DARLING HARBOUR LIVE (DHL)

ICC HOTEL

SUPPLEMENTARY PUBLIC DOMAIN DESIGN REPORT FOR SSD6116

MARCH 2014

Figure 3.1.1 Porte cochere

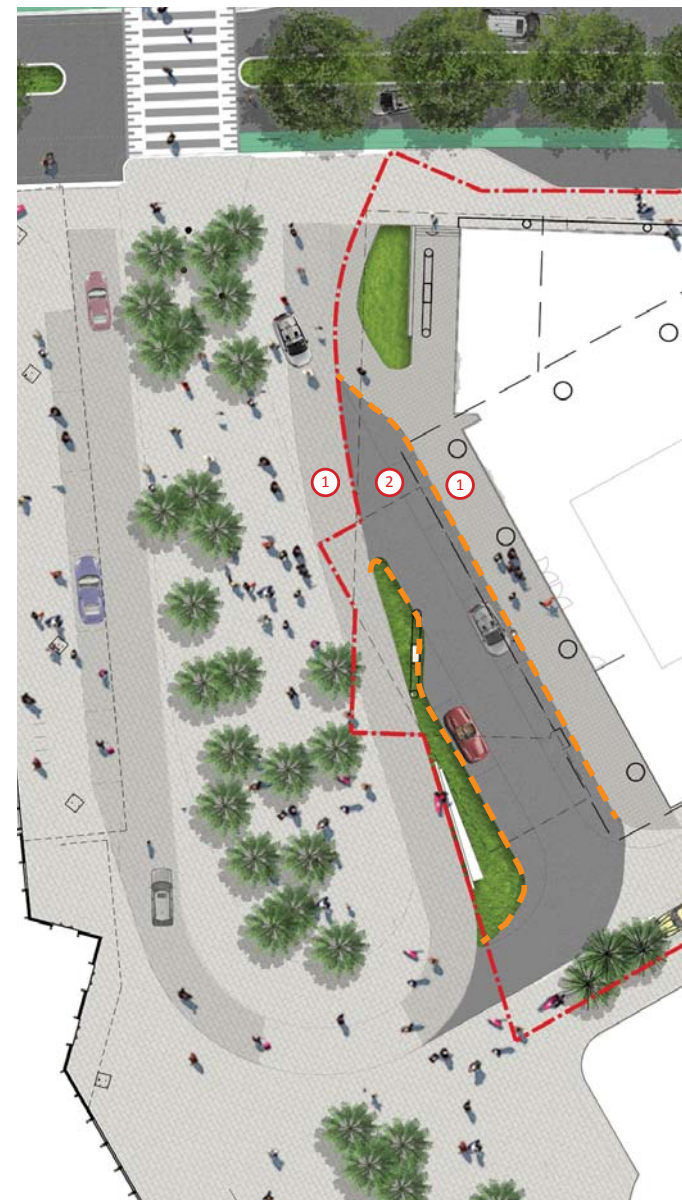
04. Further clarification of the use and operation of the porte cochere to ensure it is functional and user friendly.

The porte cochere will be the key arrival and departure point for the ICC Hotel, servicing guests and visitors accessing the hotel on foot and by vehicle. As such the porte cochere will be designed to safely accommodate pedestrian and vehicular use as is typical in this environment.

Harbourside Place and the ICC Hotel porte cochere area will be operated as a shared zone with a vehicular controlled speed to 10kph, ensuring pedestrian priority and safety. Through vehicular movement within the porte cochere area will be maintained via the provision of parking bays on either side of the movement zone, with vehicle access constrained by upright kerbs (*Refer Figure 3.1.1*).

Additionally, vehicles entering the porte cochere drop off area from Harbourside Place will be alerted to a pedestrian interface through a change in surface materiality. The change in colour and shift in scale from a large size unit paver to a small scale cobble generates a subtle rumble in texture and sound which will assist in alerting attention to a change of environment.

Similarly, pedestrians will be sensitive to vehicular circulation through the above mentioned materiality changes as well as the kerb step down from the hotel lobby onto the drop off zone.

Figure 3.2.1 Pedestrian and vehicular movement

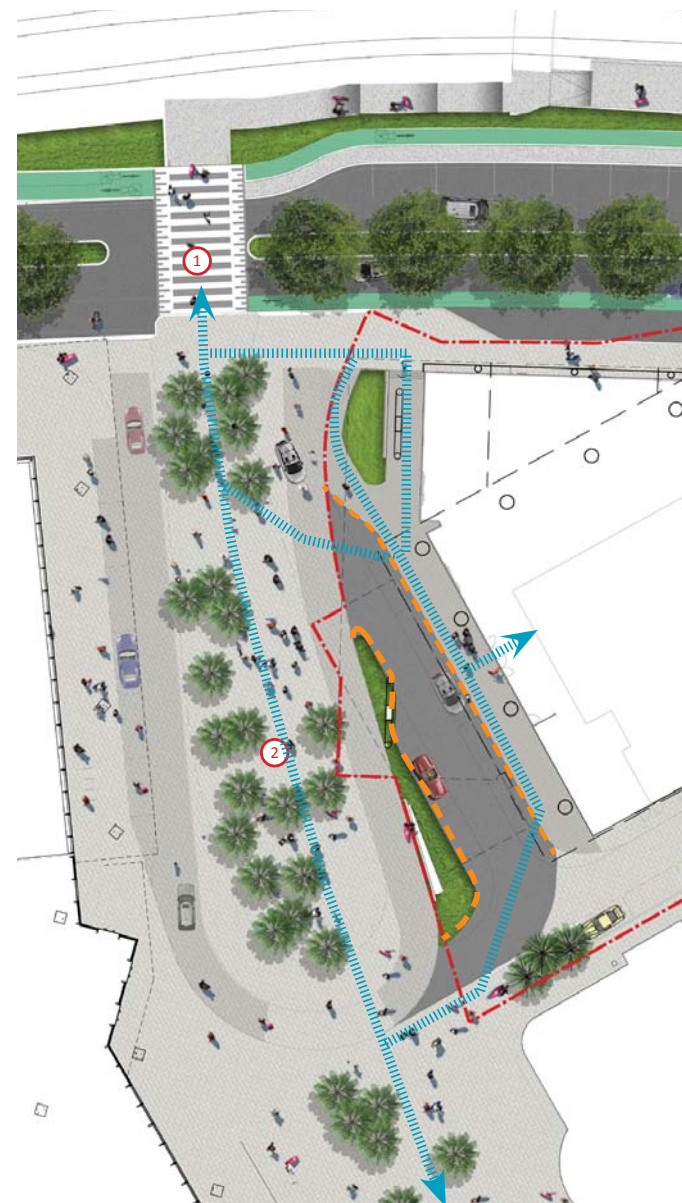
06. The pedestrian connection from Darling Harbour to the Convention Light Rail stop must be safe, efficient and clearly delineated. The potential for conflict along this main pedestrian linkage should be assessed, due to the proposed location of the porte cochere and associated vehicles that will access the area.

16. Transport for NSW suggests that clear signage to guide pedestrians and cyclists through the area and to bicycle facilities should be provided during the construction stages and after completion.

The pedestrian connection from the Convention Light Rail stop, across Darling Drive and through to Cockle Bay has been approved under a separate Development Application. In order to ensure an integrated public realm design which is safe and considered the design of the ICC Hotel Public Realm has been developed as part of one integrated precinct ensuring the best possible design outcome for the broader Harbourside precinct.

A key outcome of this review has been the modification of the connection over Darling Drive from a scramble crossing to a signalised crossing. Pedestrians alighting at the Convention Centre Light Rail stop as well as cyclists travelling towards the SICEEP site can now utilise this crossing to safely move into Harbourside Place.

Hotel visitors and staff will then continue their route through the Harbourside Place pedestrian priority zone and will be provided with two options to traverse over and into the porte cochere area and the hotel lobby, these being:

- Route one leads towards the bus/ coach stop to the North and from there provides abled body access along The ICC Hotel facade or ramp access along the planting bed;
- Route two continues further into Harbourside Place and then allows for multiple access points in between the two planting zones demarking the entry of the hotel

Harbourside Place and adjoining drop off zones for ICC Hotel and Convention are managed as a shared and slow speed environment and prioritise pedestrian movement. Careful selection of materiality and subtle level changes will further assist with delineating and controlling vehicular movement in order to create a safe pedestrian experience.

Directional signage will support wayfinding to the core facilities, key nodes and public realm areas as well as key amenities including bike end of trip facilities.

Figure 3.3.1 & 3.3.2 ICC Hotel end of trip facilities

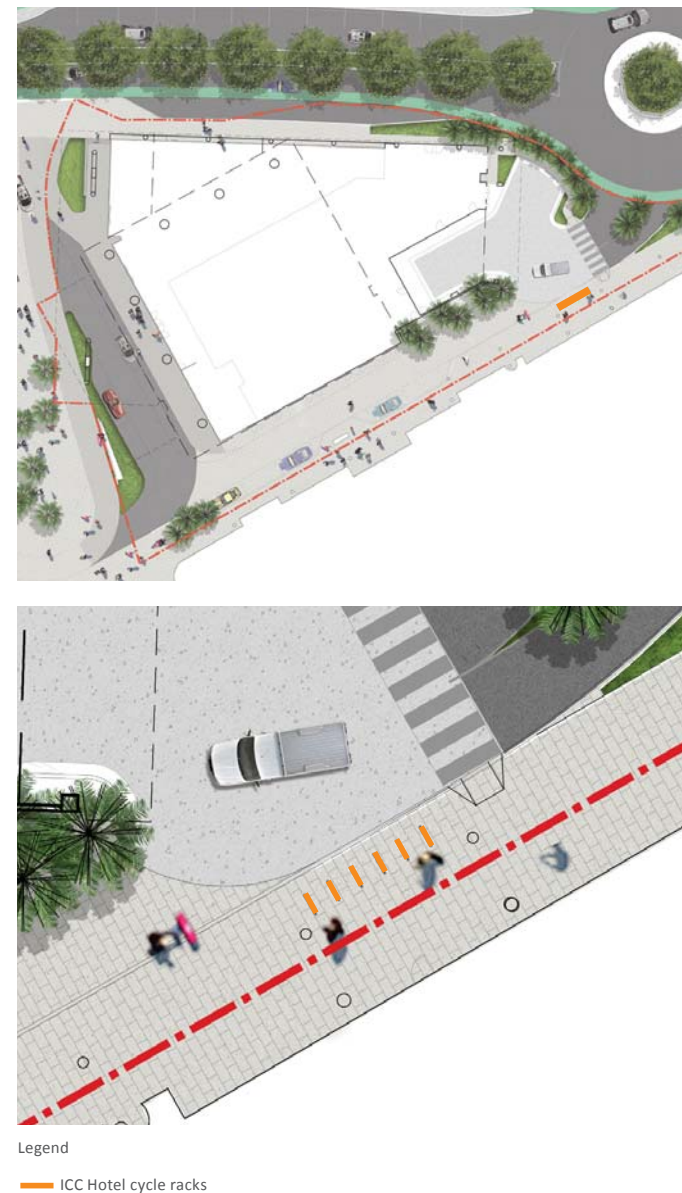
07. Bicycle parking in line with requirements of the NSW Planning Guidelines for Walking and Cycling should be provided. In line with the City's Sydney DCP 2012, 33 personal lockers and 2 showers should be provided for staff, with associated changing facilities.

05. Details of bicycle parking and associated end of use facilities for staff.

14. Bicycle parking that adequately meets the requirements of future employees and visitors shall be provided. The report does not mention any provision for bicycle parking either for staff or visitors to the SICEEP.

The ICC Hotel now includes the following amenities:

- 15 bike spaces within the building for staff
- Change facilities
- Female/ male/ accessible toilets
- Female/ male showers
- 12 spaces for visitors within the public realm

Figure 3.4.1 Cycle network

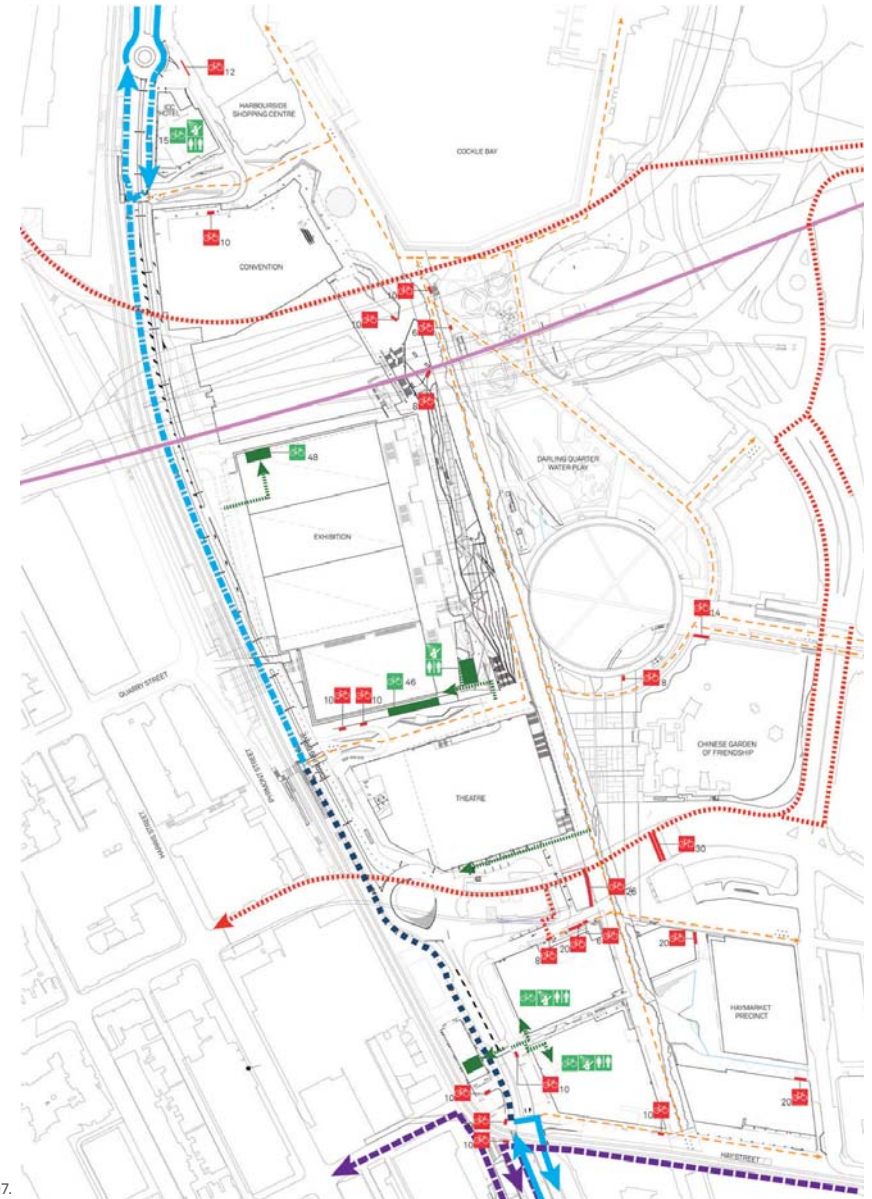
10. The NSW Government has released the Sydney City Centre Access Strategy. The strategy includes an outline of the city centre cycleway network and is provided in Attachment 3.

Darling Harbour Live (DHL) will provide cycle access as shown on *Figure 3.4.1*. This is broadly in alignment with the Sydney City Centre Access Strategy. Subtle variations are proposed as detailed below.

Darling Drive will offer a continuous cycle link, connecting Pyrmont Bridge to Hay Street and beyond. This link will change character along its extent in order to accommodate varying constraints:

- North of Harbourside Place the cycle way will be separated and single lane in order to connect into the existing cycle network beyond our site.
- The section in between Harbourside Place and Tumbalong Place will be shifted and combined as a dedicated bidirectional cycle path along the Western edge of Darling Drive.

- In between Exhibition Light Rail stop/ Tumbalong Place and Hay Street the dedicated bike path changes into a pedestrian and cycle shared environment. The section from the Exhibition Light Rail stop/ Tumbalong Place to south of Pier Street roundabout is approved under the PPP development consent. Spatial constraints and the need for a direct pedestrian access in between light rail stop and student housing did not allow for another alternative.

- South of Hay Street the bike lanes transition into the existing on-road, single bike lanes or onto the shareway within the Goods Line (by others).

The Sydney City Centre Access Strategy further proposes a cycle connection through the centre of the DHL development. Improved East - West connectivity is a key design driver of the proposed public realm design. As such connectivity for pedestrians and cyclists will be strengthened through Harbourside Place and Tumbalong Place. In line with the targeted use and character of the public realm, cycle connectivity will be provided and encouraged, though be of an informal, shared, recreational quality. Equally, the Boulevard will allow for casual, recreational bike access.

We note that the City Centre Strategic Cycle Network as per attachment 3 of TfNSW's submission from 23 December 2013 is inconsistent with the proposed 'strategic cycleway network' as shown on page 45 of the Sydney City Centre Access Strategy, released in December 2013. Our above response does however address both strategies. Additionally we are in direct conversation with TfNSW to conclude a final concept that is appropriate for the character and use of the DHL development whilst maintaining and strengthening the regional cycle network strategy.

Figure 3.6.1 Loading bay zone

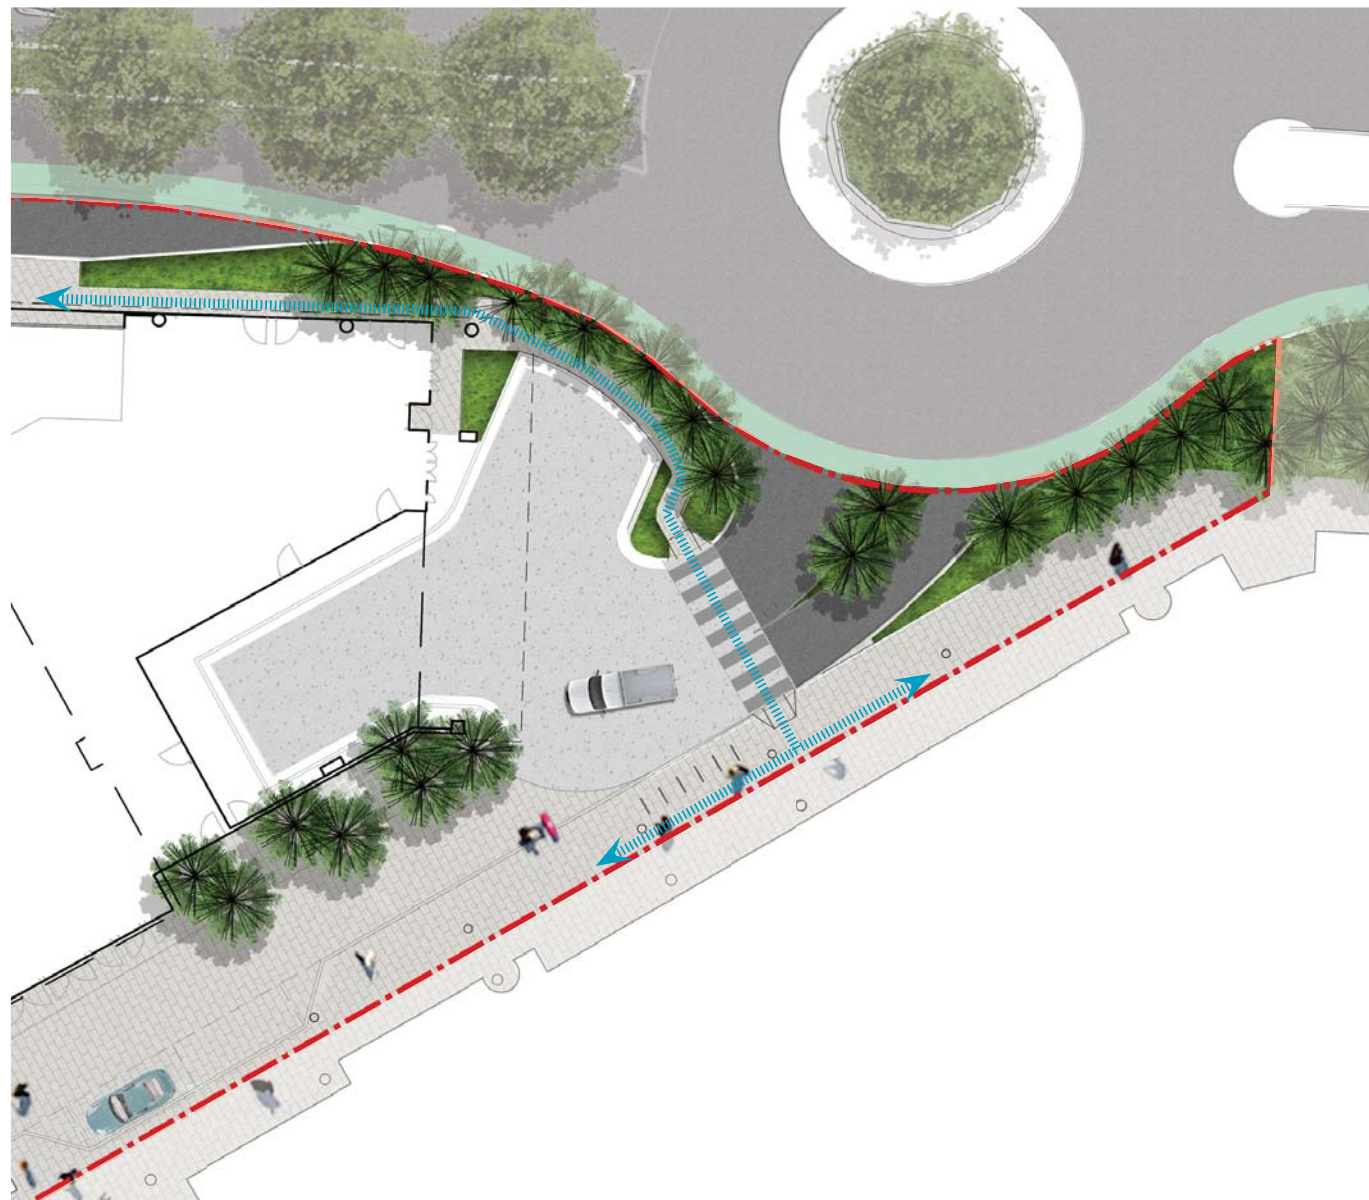
09. A key concern is providing treatments to discourage pedestrians from entering the service vehicle turning bay. This should be considered by the proponent.

Pedestrian safety in the loading zone area will be managed via passive and active means.

The change of materiality, from a high quality surface finish (granite paver) within the pedestrian zones to a lower quality finish (concrete & asphalt) within the vehicular priority spaces will passively guide and alert the pedestrian to the appropriate path of travel as required.

Signage will further assist in denoting safety conflict areas.

Landscapes zones and, if required, physical barriers will additionally support safe travels from the bus stop towards the crossing and beyond.

Drawing Title
SECTIONAL ELEVATIONS
(SHEET 1 OF 2)

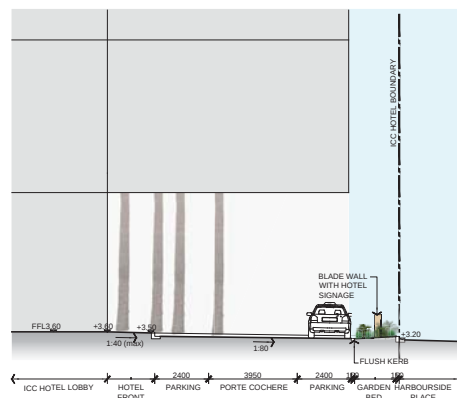
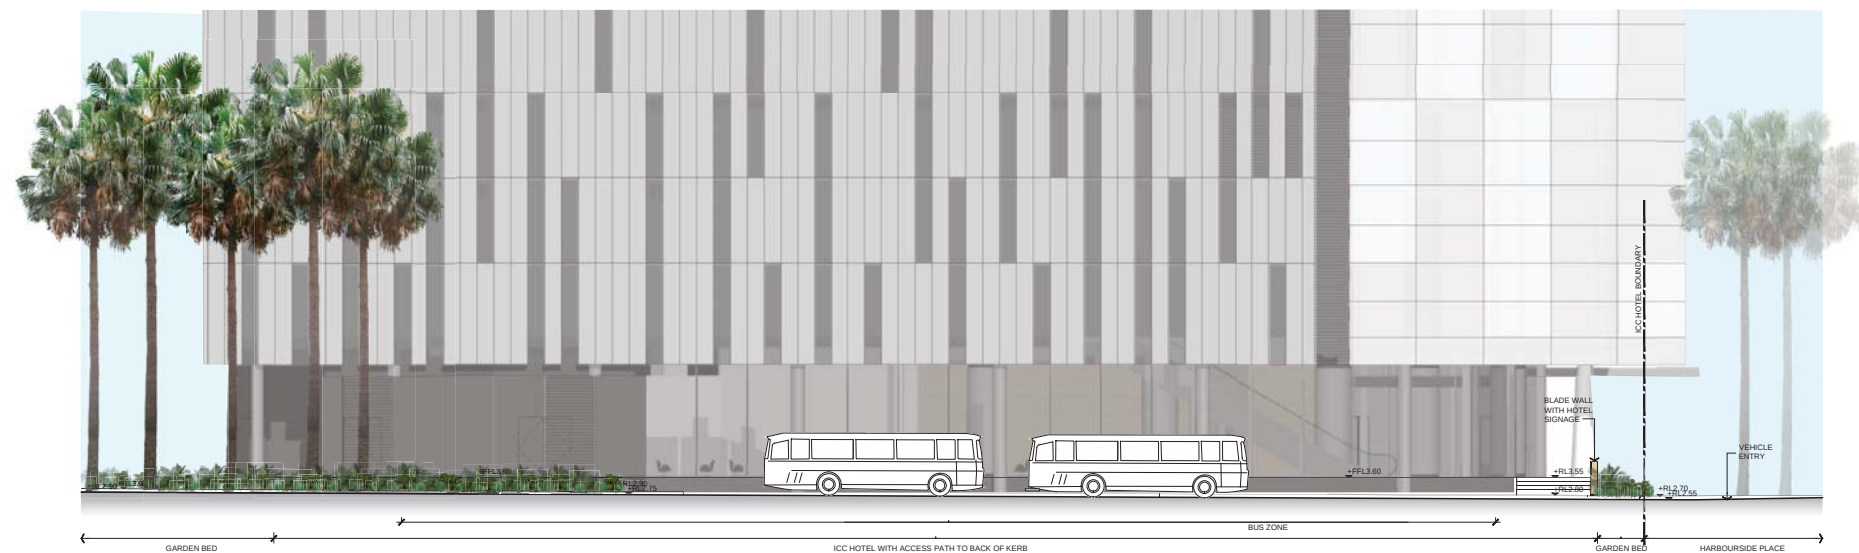
b) drawing number 'L601 Sectional Elevations' is duplicated. For clarity, sheet 1 and sheet 2 should be given a different drawing number.

The drawings have been updated to include the original drafting date. The section drawing numbering has been corrected and been updated as L601 and L602. Please refer attached drawing package.
